FMTV...

Get Upgraded M777 Howitzer Latch Kit

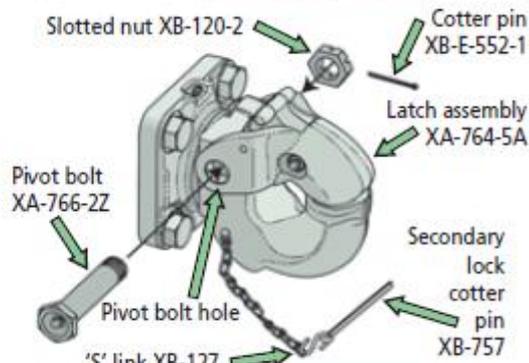
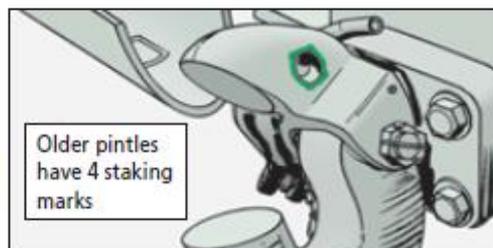
But chances that this separation could happen are increasing with older versions of the M1083 or M1093 pintle hooks that use a staked latch pin assembly. You can identify these old-style pintles by the four staking marks on each side of the latch pin. They make sure the pins stay in the latch assembly.

Prevent separation while towing by getting the upgraded pintle latch kit. This new RK-775 latch kit, NSN 2540-01-579-6710, replaces the upper pintle hook latch assembly with a non-staked, positive retention assembly.

Instructions and the items to the right come in the RK-775 kit:
